SUBJECT: ADMINISTRATIVE CONTROLS (TAC 57015, 57016, 55733, 55734)

Re: Quad Cities Nuclear Power Station, Units 1 and 2

The Commission has issued the enclosed Amendment Nos. 100 and 97 to Facility Operating License Nos. DPR-29 and DPR-30 for the Quad Cities Nuclear Power Station, Units 1 and 2. The amendments are in response to your application dated February 17, 1983, and supplemented and superseded by letters dated August 23, 1984 and January 20, 1986, respectively.

Quad-Cities Station Organization
Figure 6.1-2

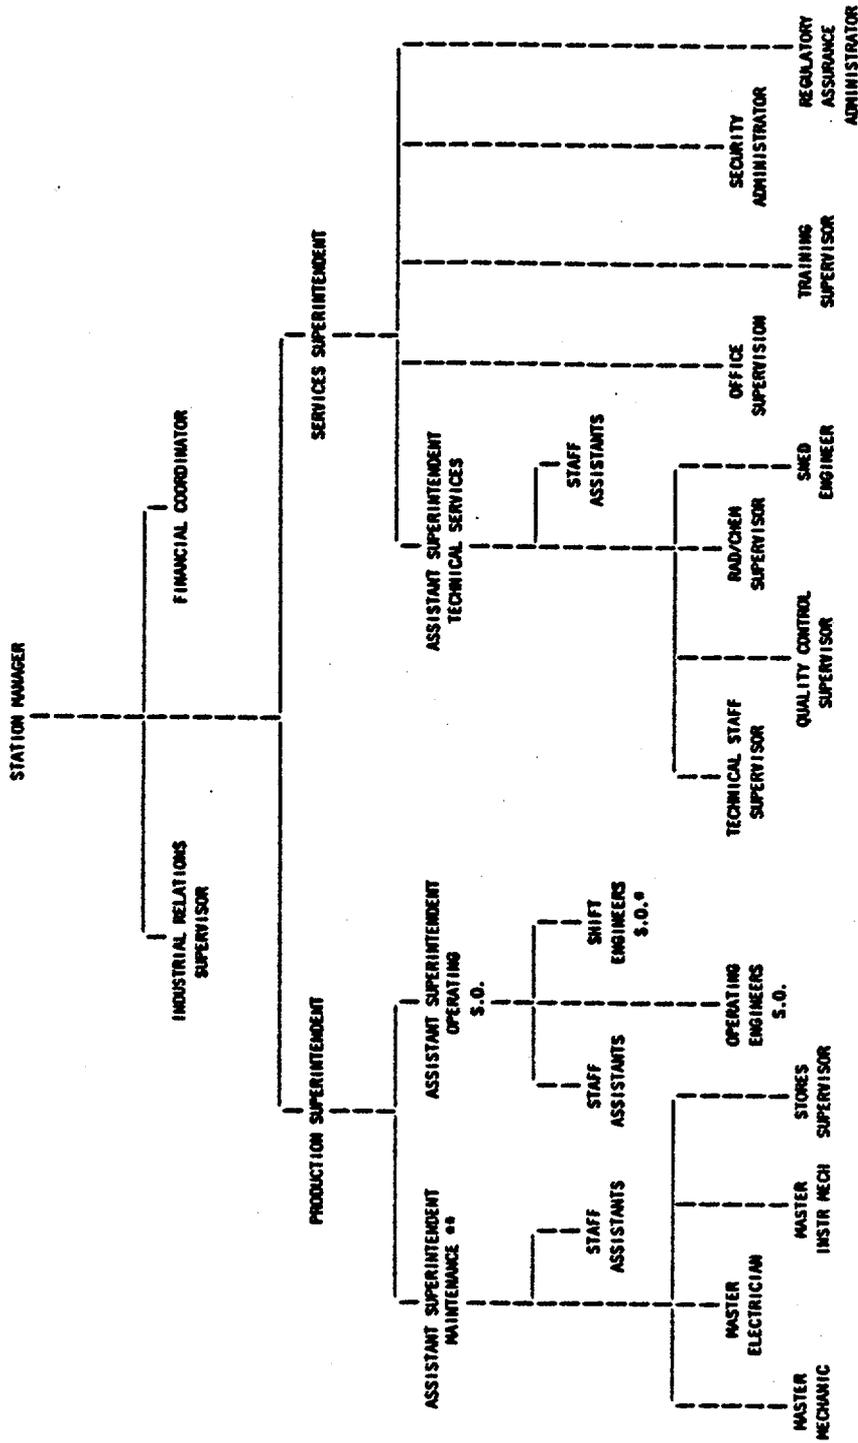
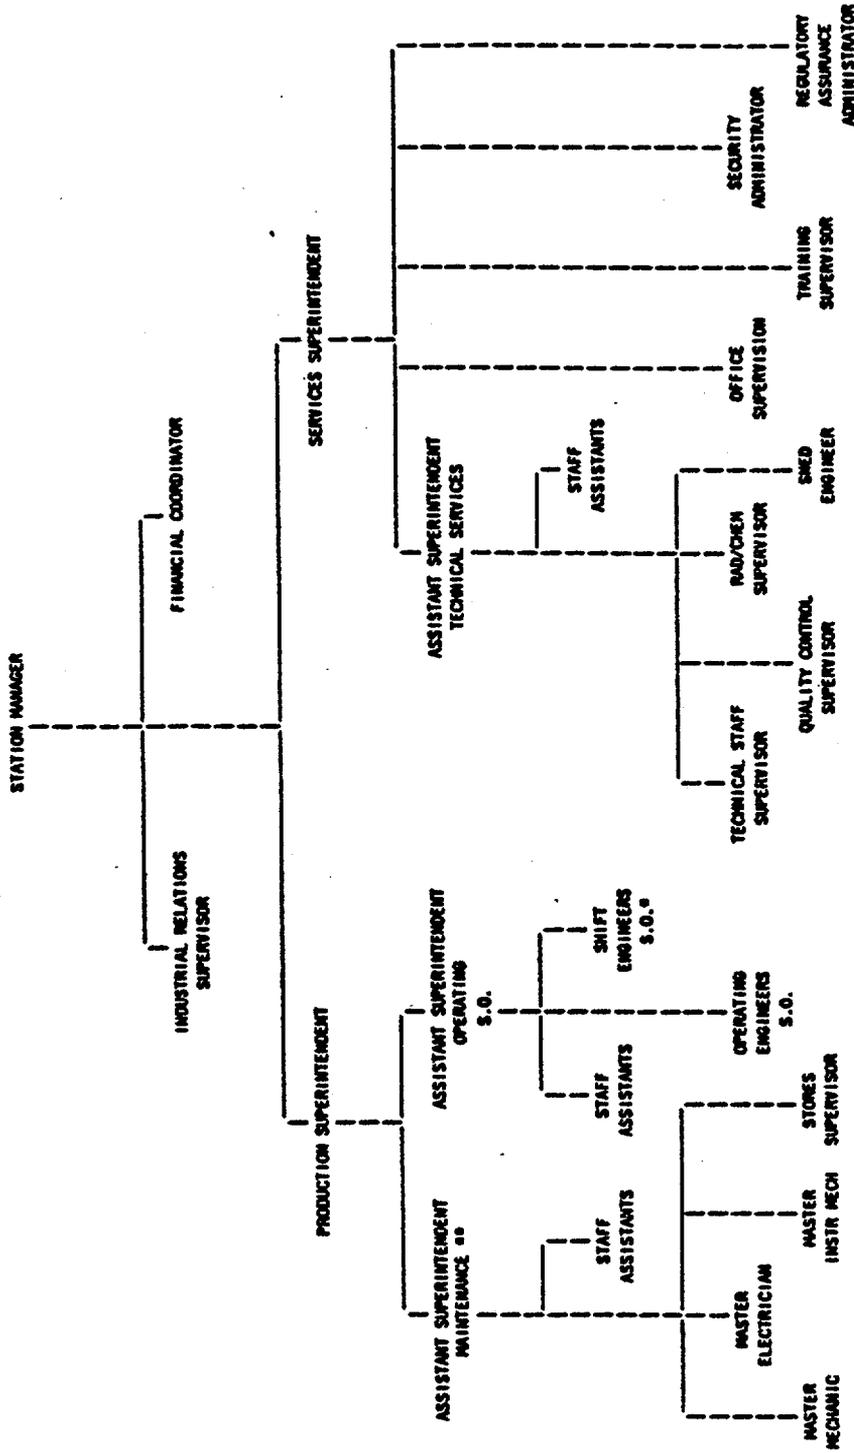
Figure 6.1-1, "Corporate Organization," and Figure 6.1-2, "Station Organization," have been revised. These changes reflect the current Commonwealth Edison (CECo) organization as depicted in CECo Quality Assurance Manual, Revision 12. Changes reflecting new titles delineated in the organization charts are made. The changes are appropriate and in agreement with the Quality Assurance Manual, and are therefore acceptable.
